KANE NSS.378 / NSS.378-1

ISSUE 7.1

BLOOR HOMES

DRAWING: **SETTING OUT PLAN (SUSPENDED SLAB)**

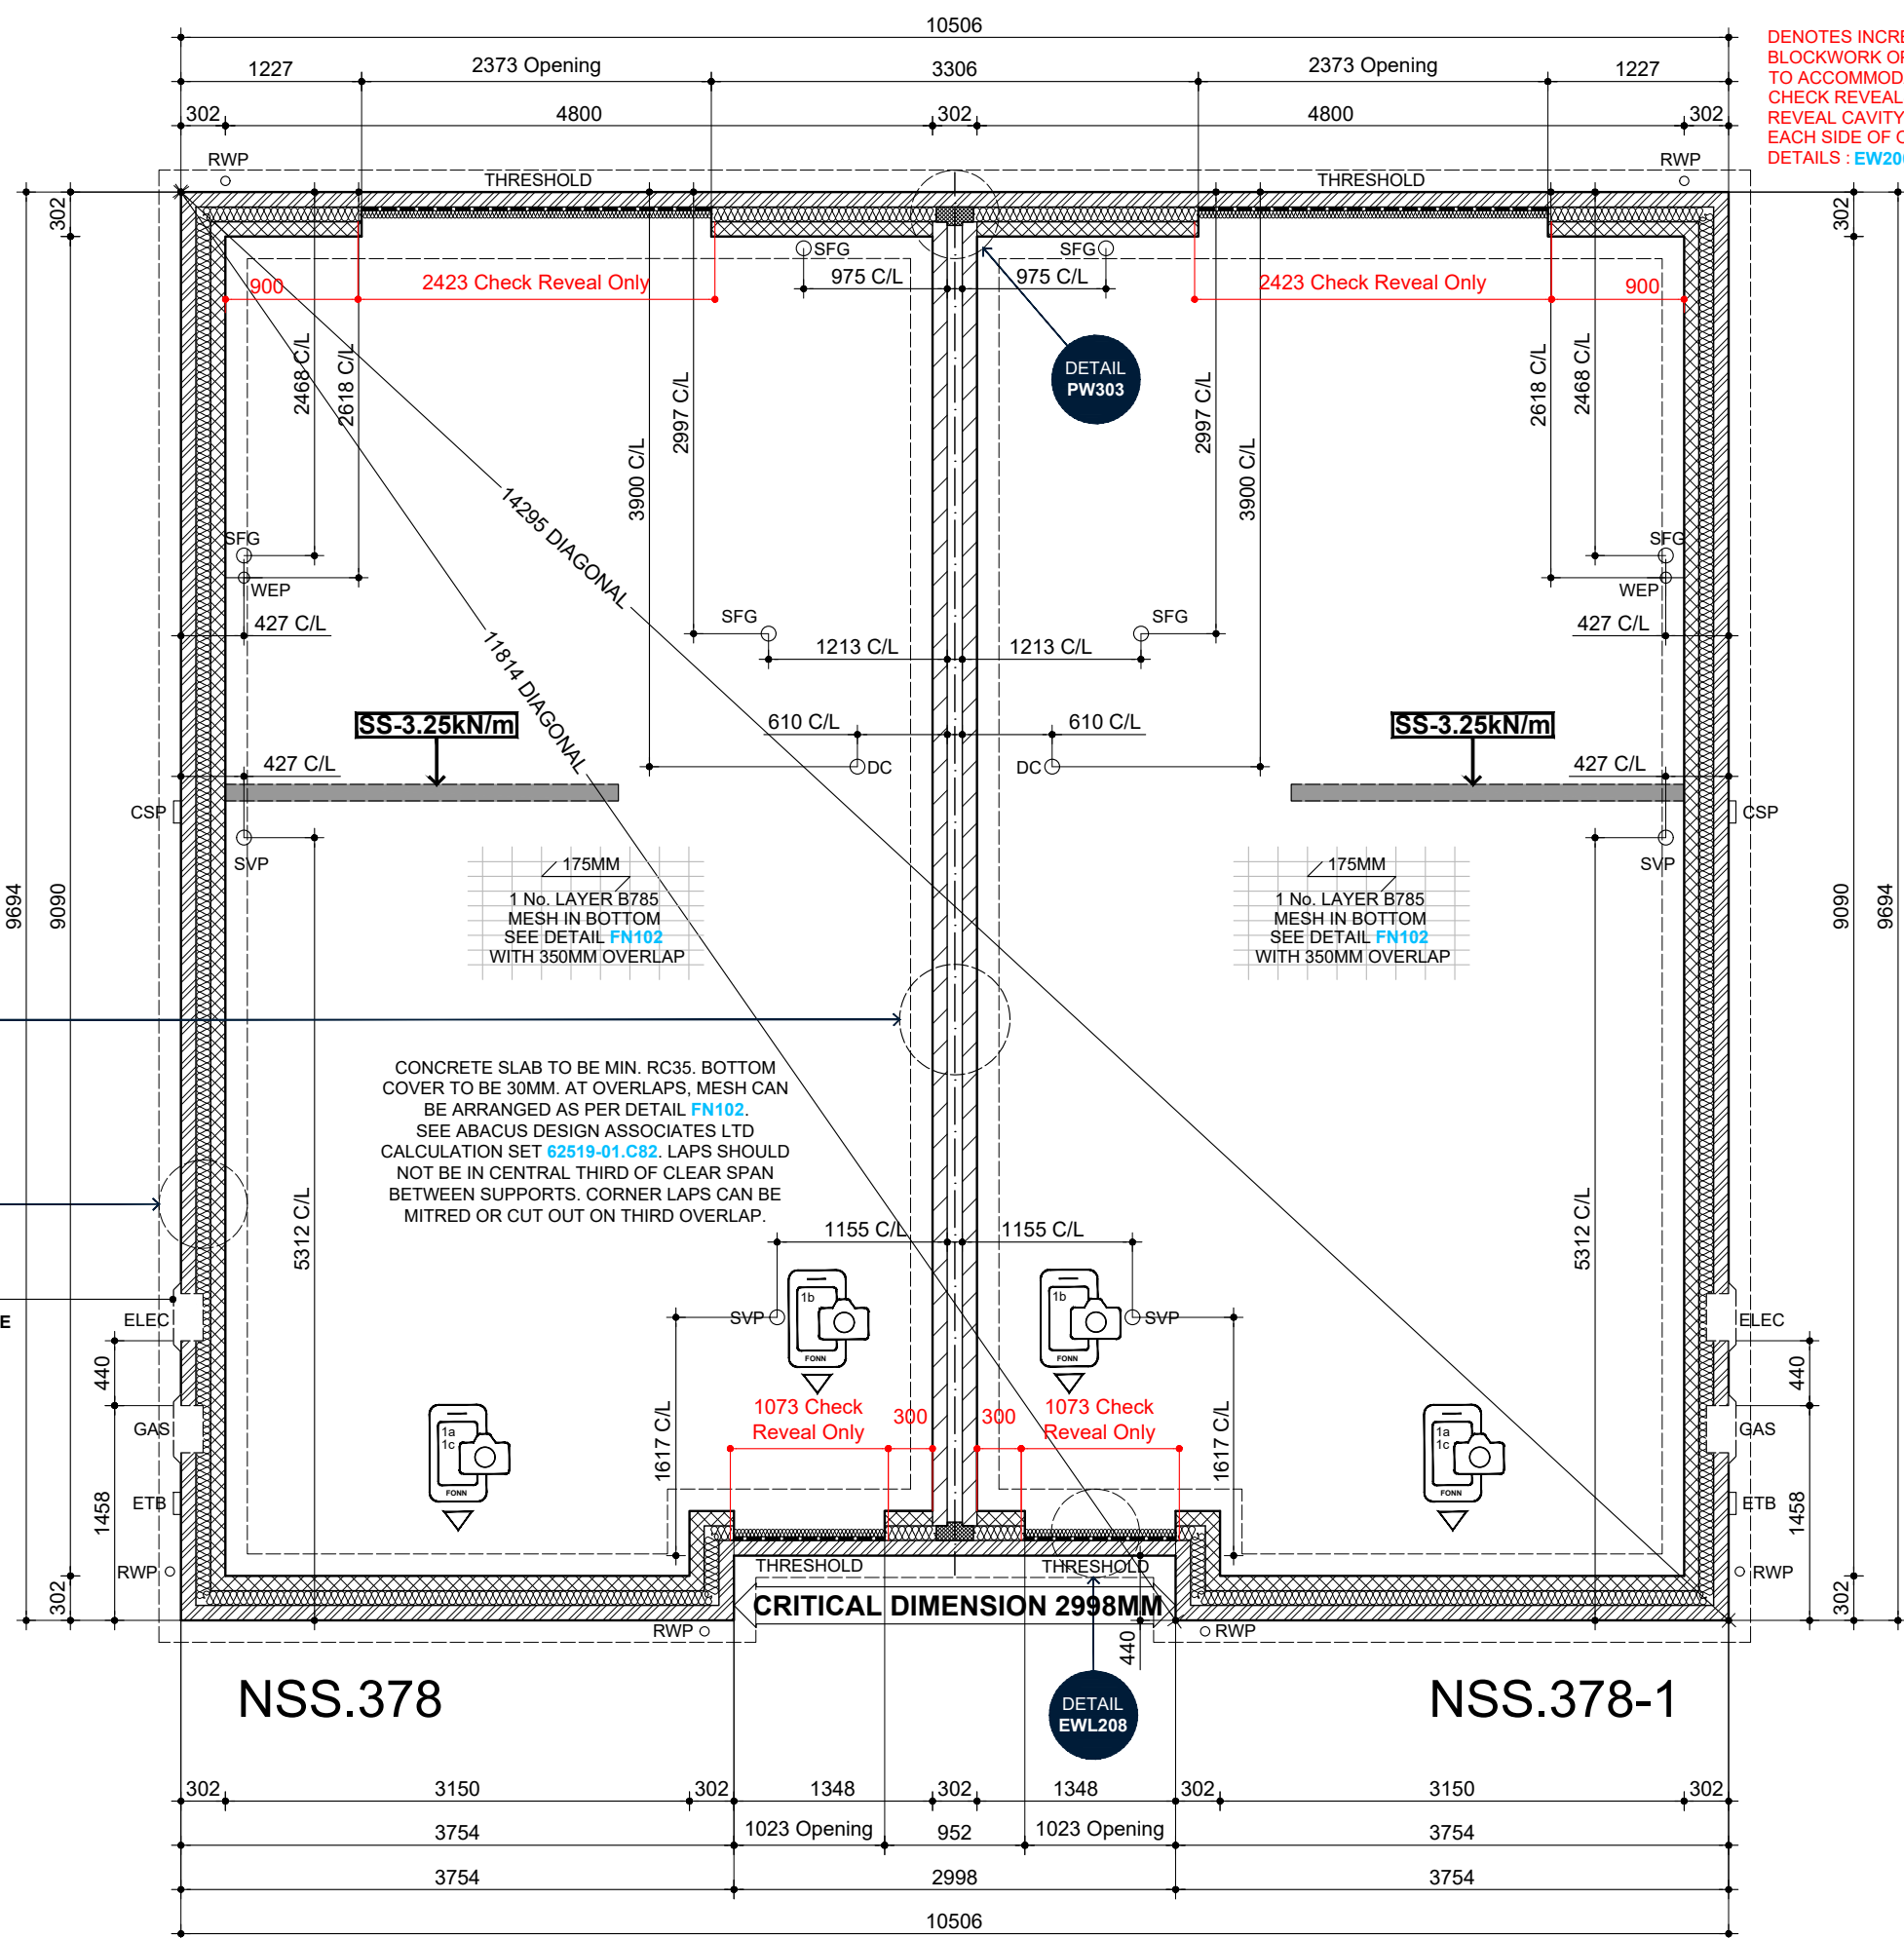
SVP IN LOUNGE REPOSITIONED
TO AVOID CLASH WITH BEAM AND
BLOCK DESIGN.

DRAWING: SETTING OUT PLAN (BEAM AND BLOCK)

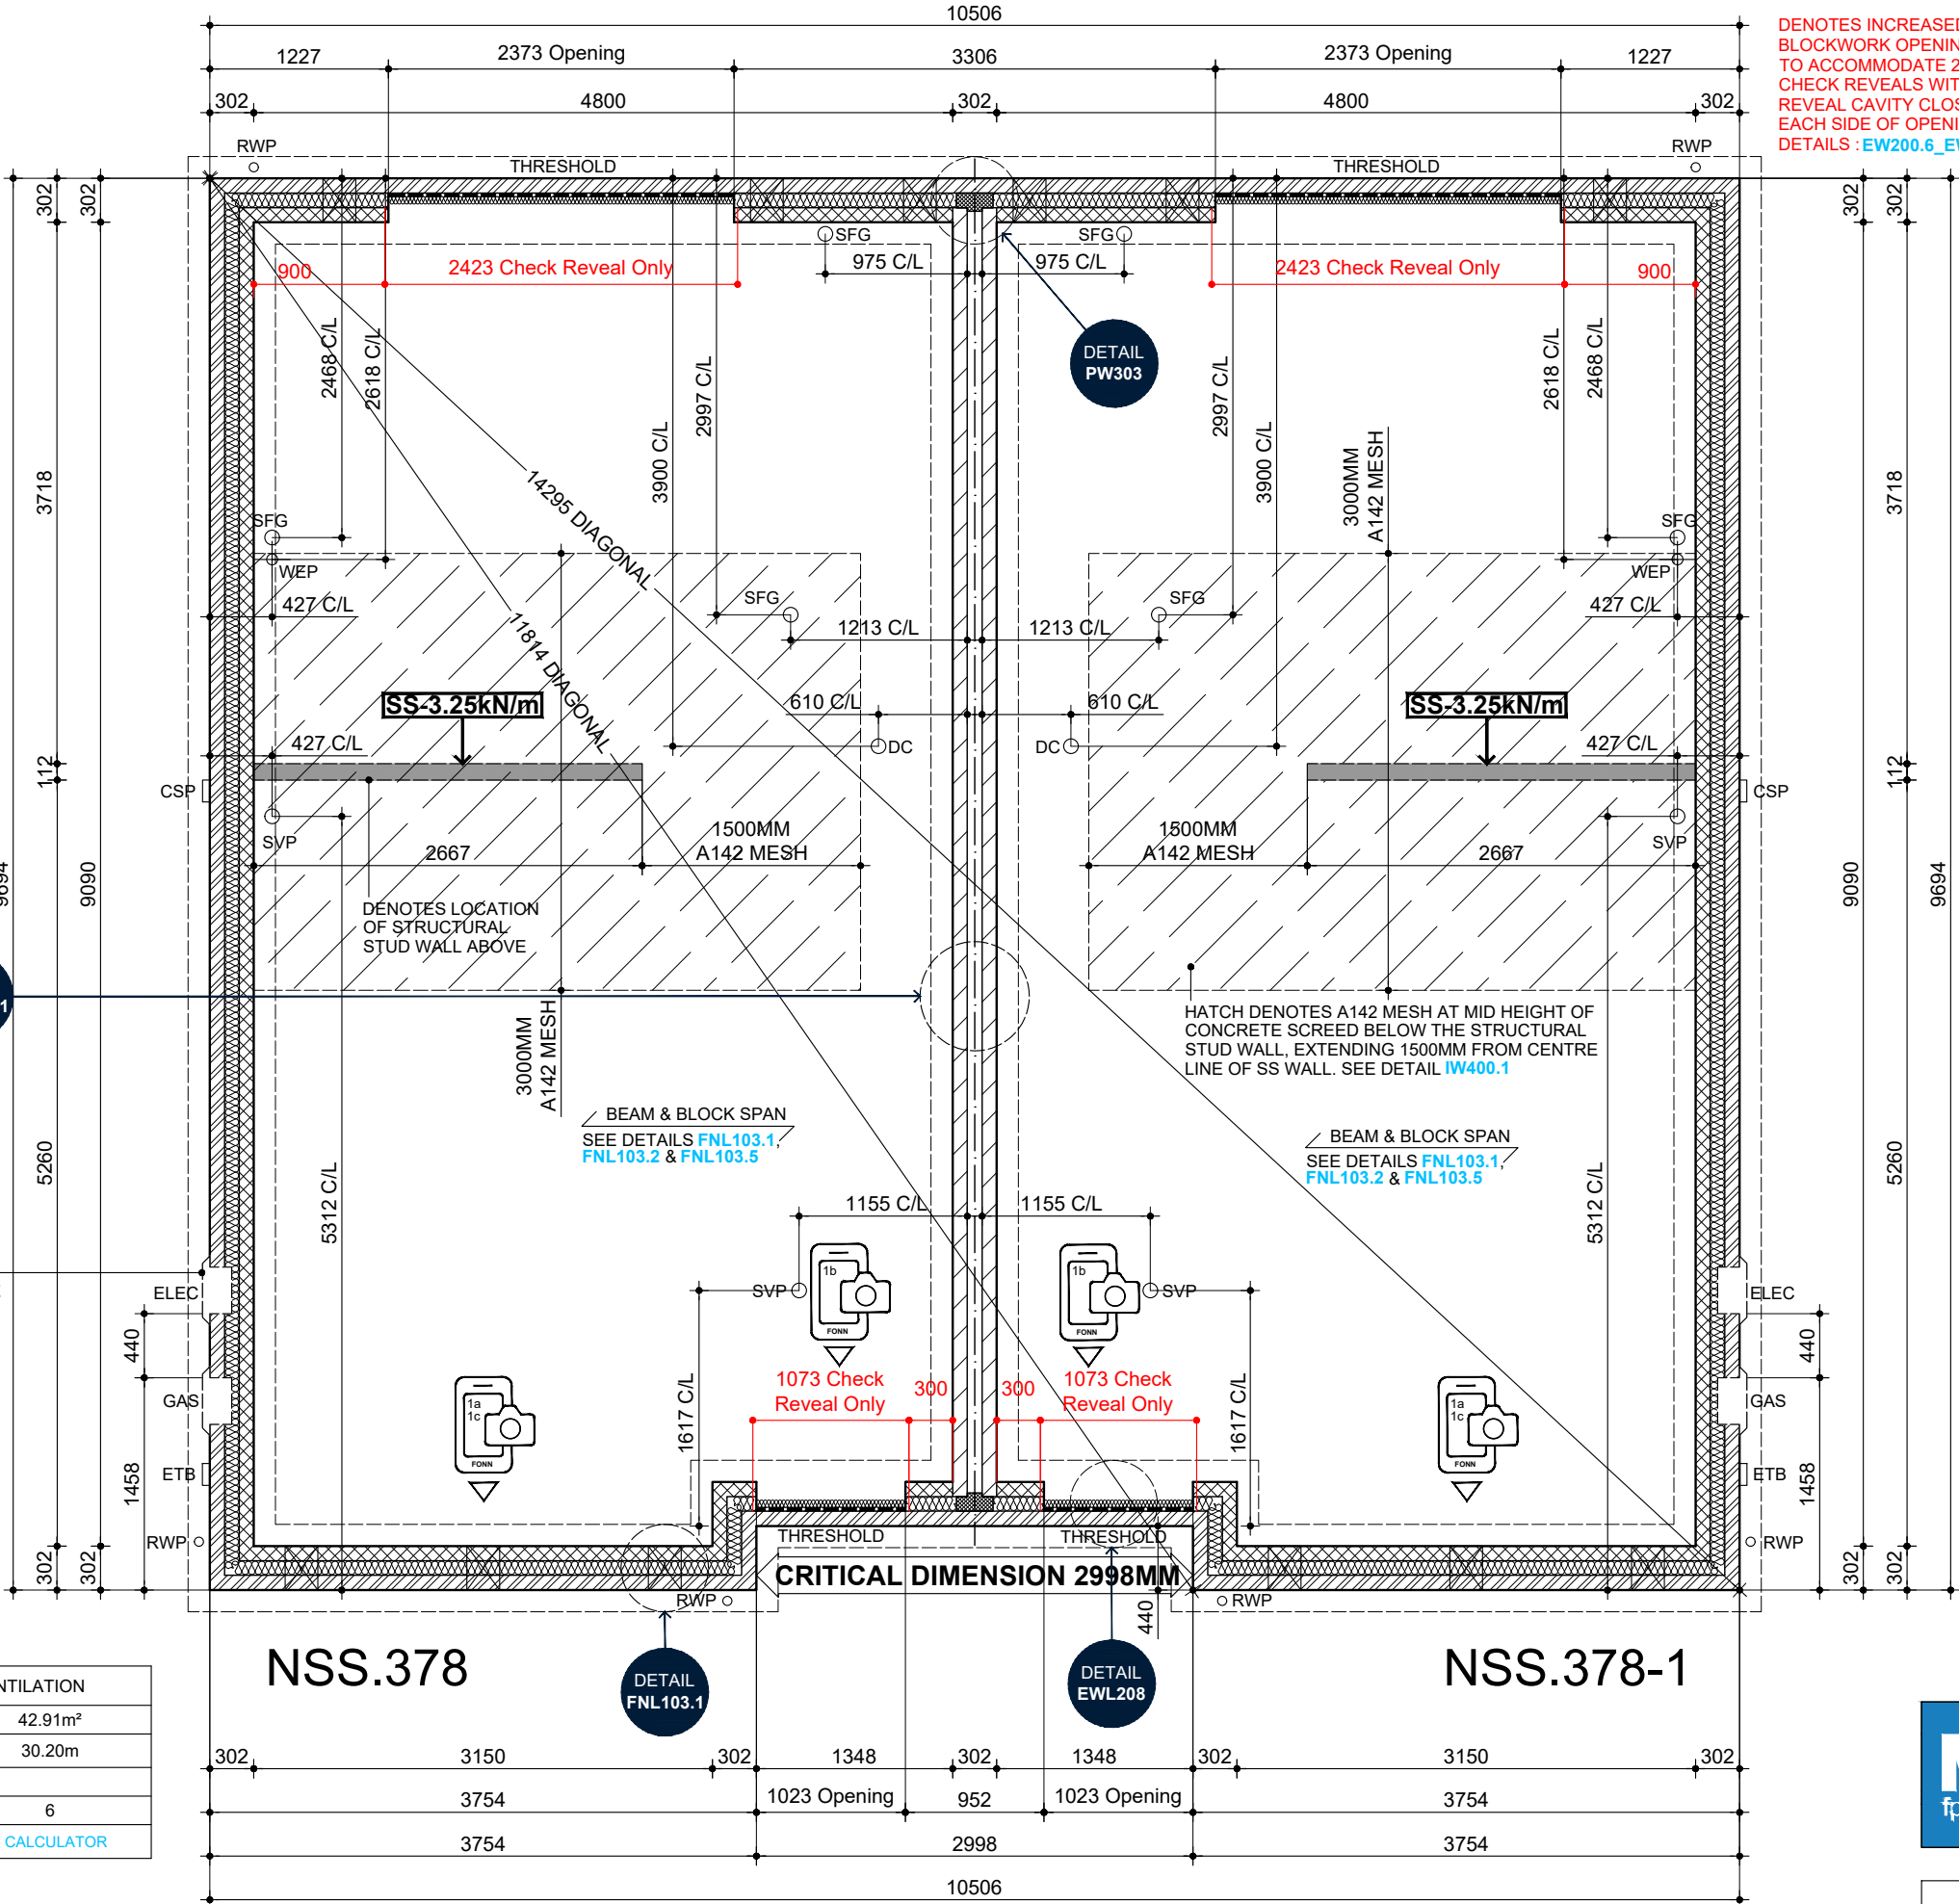
REV: **7.1**
NOV 2024
CHECK REVEAL DIMENSIONS ADDED TO
INTERNAL BLOCKWORK, NOTE
EW200.6_EW200.7 ADDED.

DRAWING: GROUND FLOOR PLAN

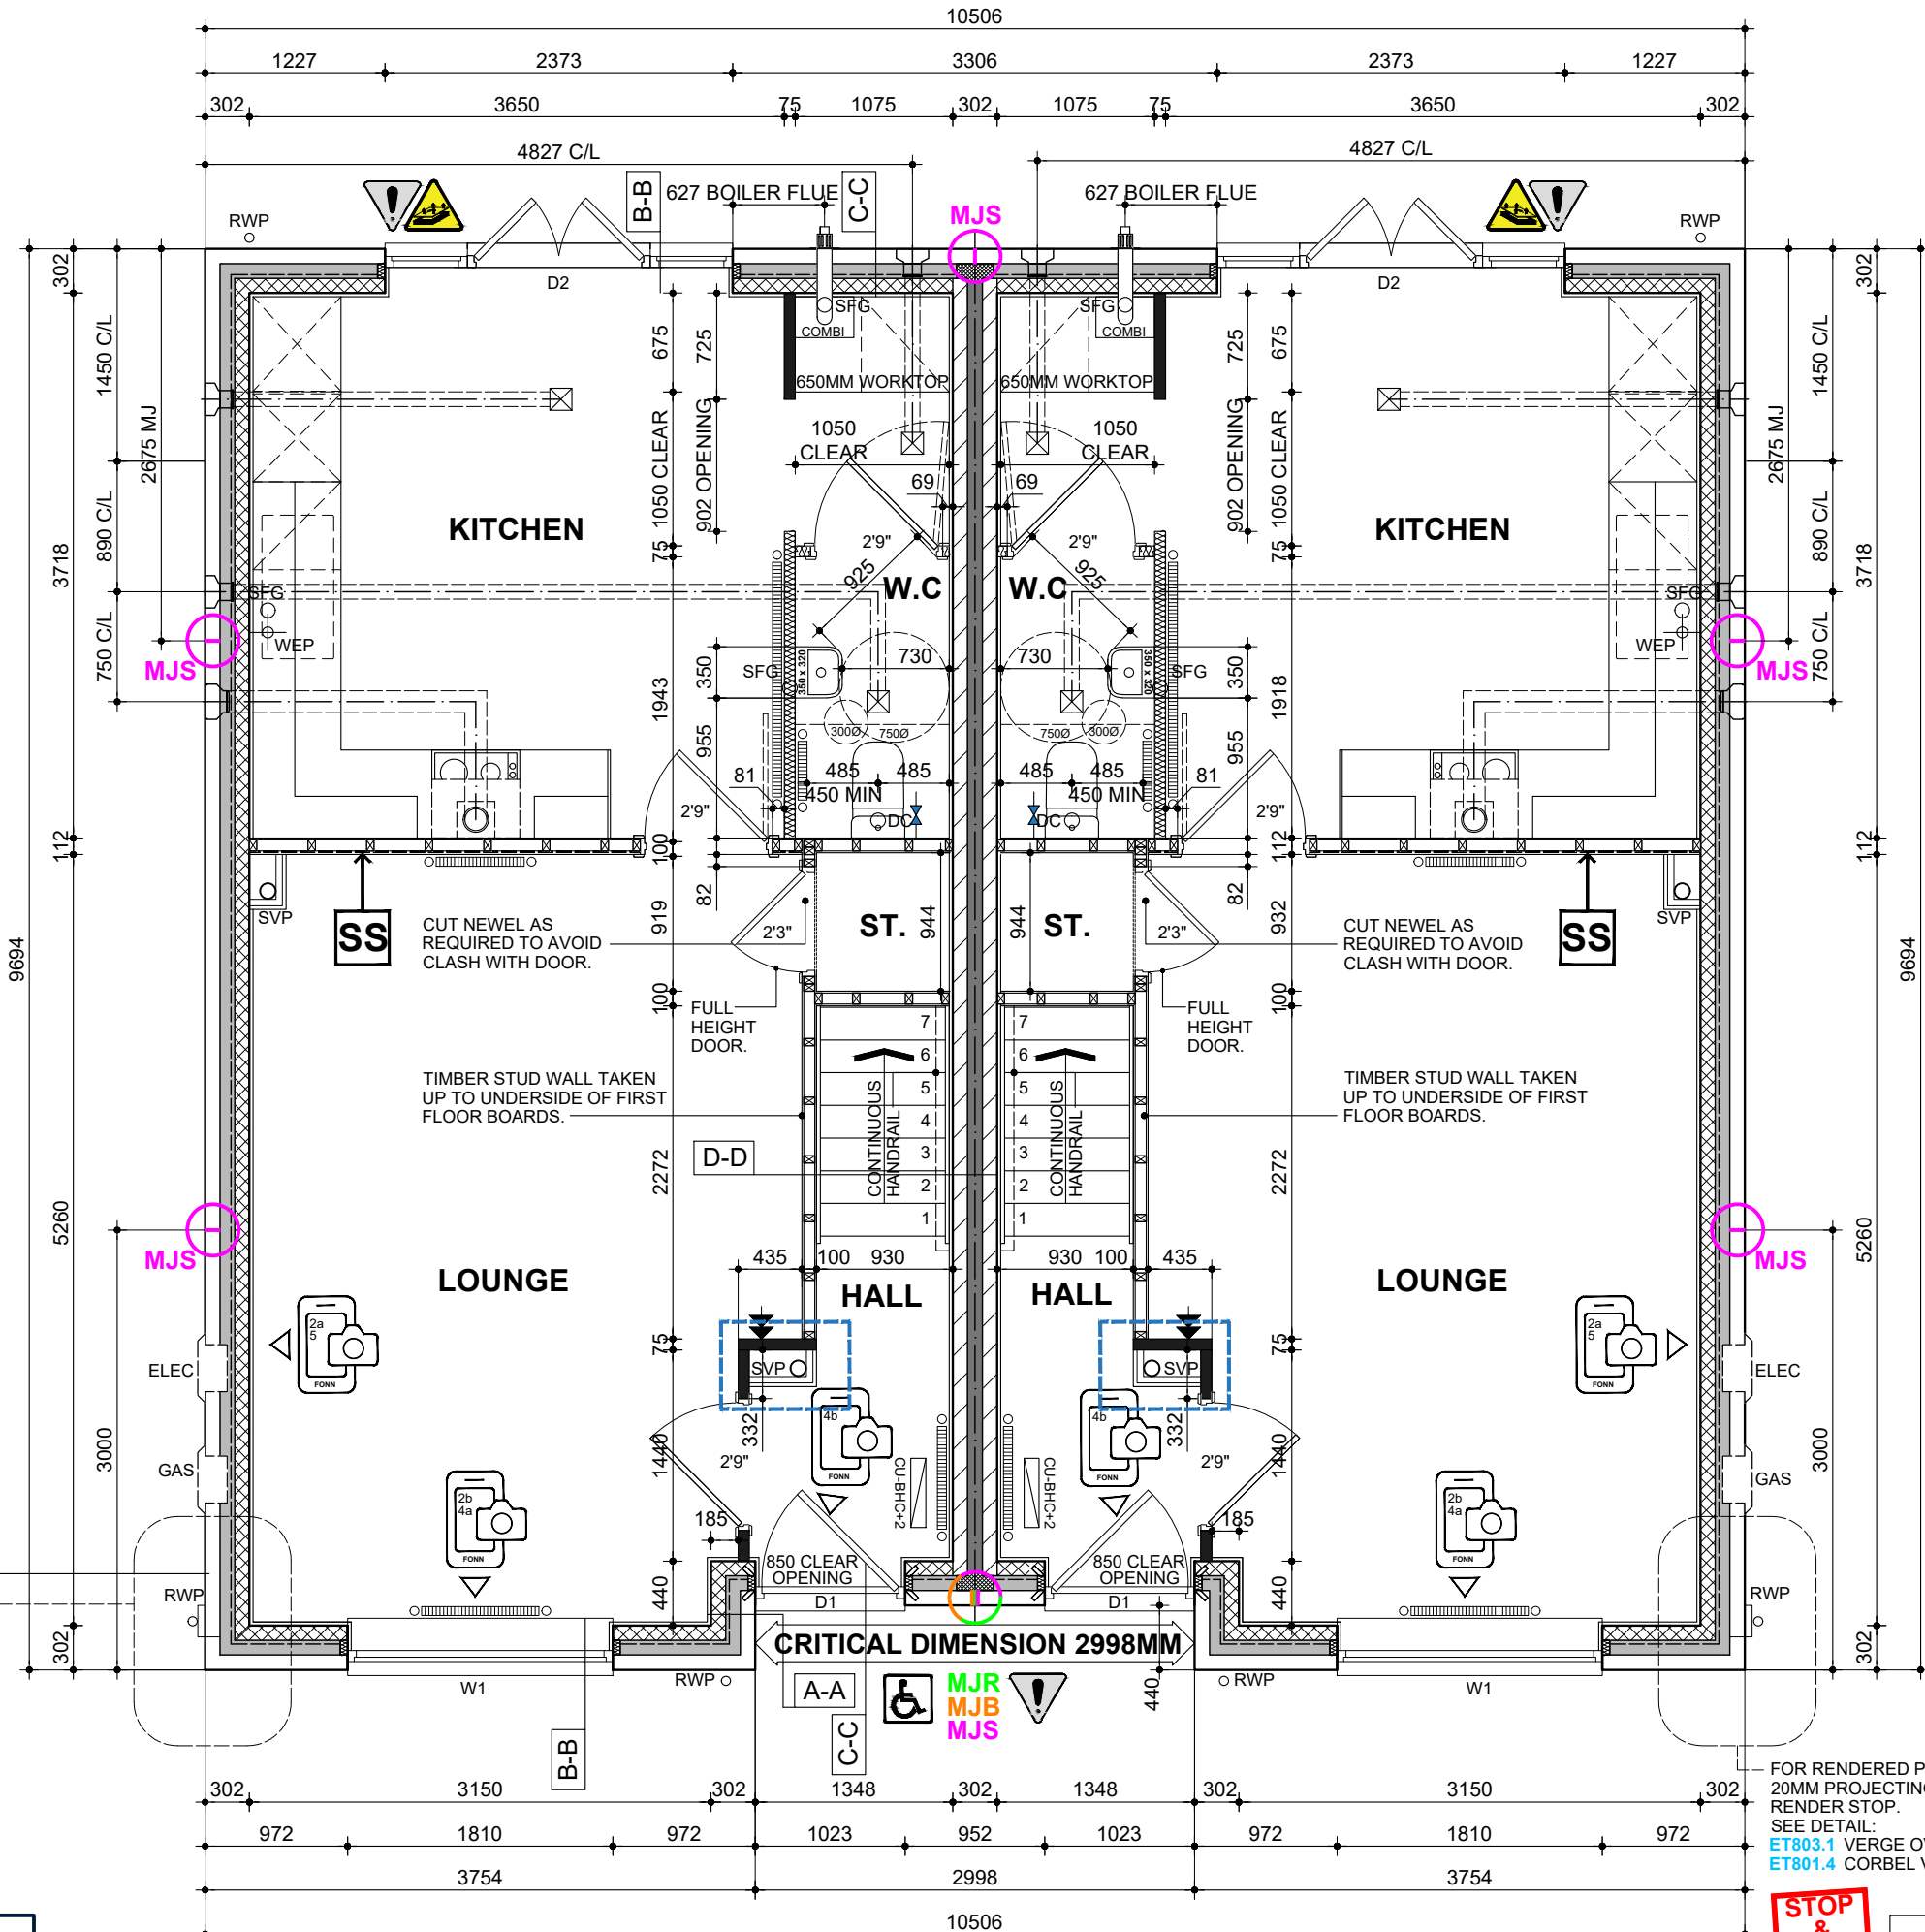
KITCHEN EXTRACT FAN POSITION
REVISED IN LINE WITH
FEEDBACK. HORIZONTAL BOILER
DIMENSION ADDED TO FLOOR
PLAN. WWHR MOVED TO HALL,
PARTITION AND WALL MOVED TO
SUIT.
